SUPPLEMENTARY REPORT

HUNTER AND CENTRAL COAST REGIONAL PLANNING PANEL

PANEL REFERENCE & DA NUMBER	PPSHCC-220-MA2023-00175 - PAN-330384	
PROPOSAL	Sec 4.55(2) Modification to DA2017/00701 - Concept Development Application - Staged development comprising of retail, commercial, residential and shop top housing - change to design (building height)	
ADDRESS	Lot 31-32 DP 864001 Lot A & B DP 388647 Lot 1 DP 77846 Lot 96, 98 & 100 DP 1098095 Lot 1 & 2 DP331535 Lot 1 DP 723967 Lot 1 DP 819134 105, 109, 111 & 121 Hunter St Newcastle 3 Morgan St Newcastle 22 Newcomen St Newcastle 66-74 King St Newcastle	
APPLICANT	Urbis	
OWNER	East End Stage 3 Pty Ltd & East End Stage 4 Pty Ltd	
MOD LODGEMENT DATE	1 June 2023	
ORIGINAL DA DETERMINATION DATE	2 January 2018	
APPLICATION TYPE	Modification Application under Section 4.55(2)	
REGIONALLY SIGNIFICANT CRITERIA	The proposal involves a s4.55(2) application which triggers consideration by the Hunter Central Coast Regional Planning Panel via the s275(2) directions under the <i>Environmental Planning & Assessment Regulation 2021.</i>

Figure 1 - Hunter Street Mall Precinct Controls - NDCP 2012

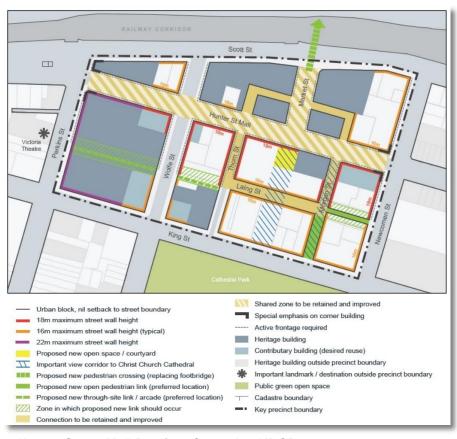
Hunter Mall Precinct controls, which directly affect the subject site and adjoining 'carpark site', include a specific view corridor between Market Street to Christ Church Cathedral to facilitate the Harbour to Cathedral view corridor (See **Figure 1** below).
